## TENDER 18-13

### WATERFRONT SEWER UPGRADES PHASE I

#### ADDENDUM NO. 3

May 18<sup>th</sup>, 2018

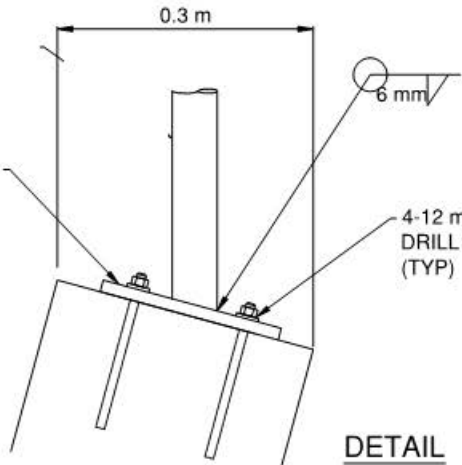
The Schedule of Quantities notes 1800mm dia manhole(s). Would this be SMH22, which is listed as 1500mm dia on the drawings (see sheet 6)?

Clarification: SMH 22 should be 1800mm diameter.

# Cast - In - Place Detail

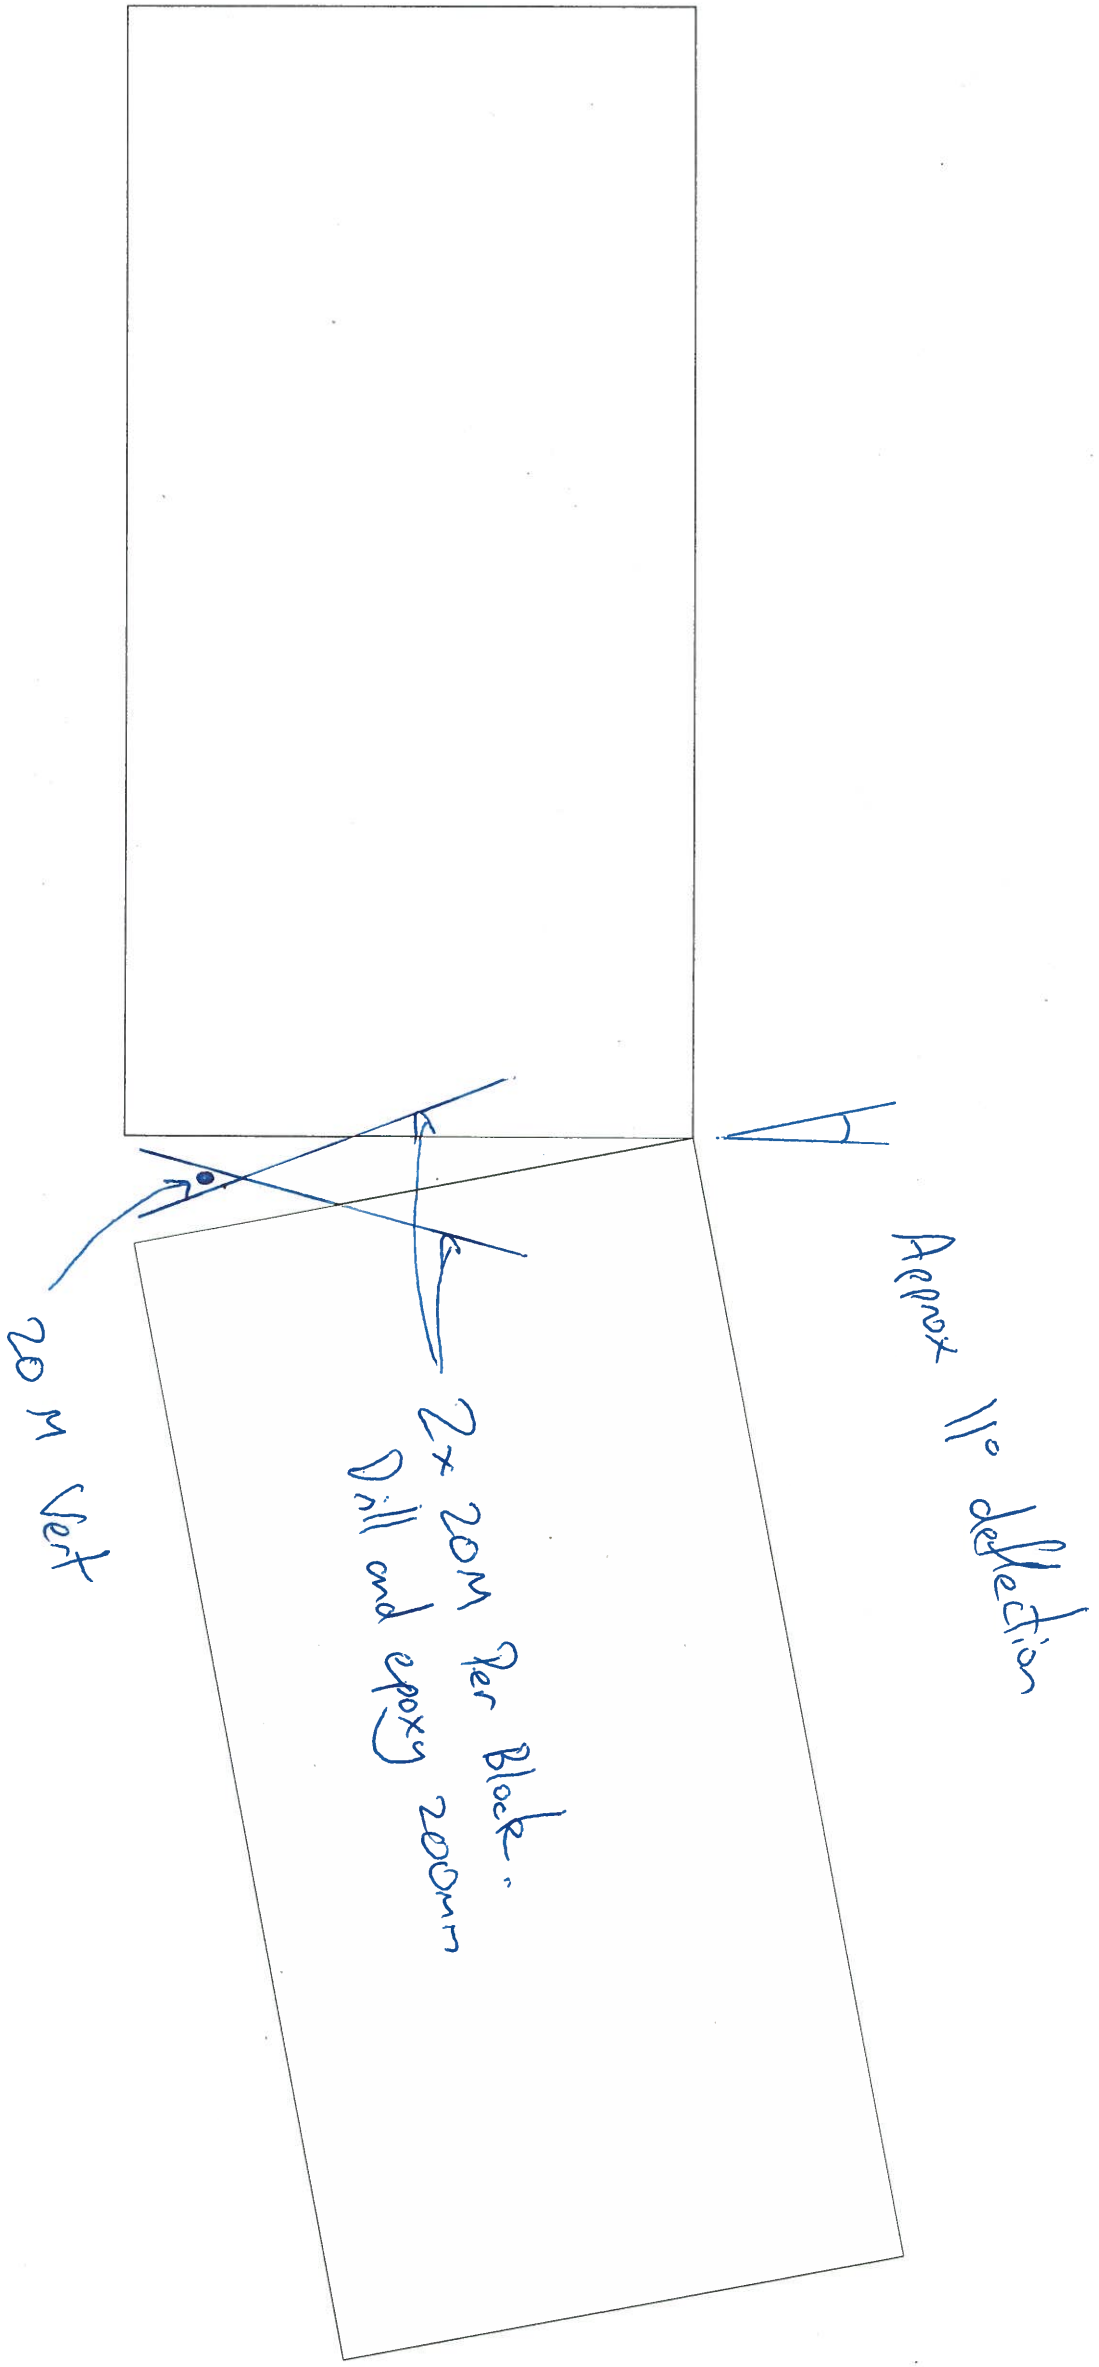
The cast in place wall at station 0+100 is transitioning from a vertical wall cut to a battered interlocking block wall joining each other at approximately 11 degrees and may require a cast in place section to transition from one wall to the other. Please provide a connection detail for the transition from the sawcut cast in place wall to the interlocking block wall.

See attached detail. Concrete to be C1 Class.
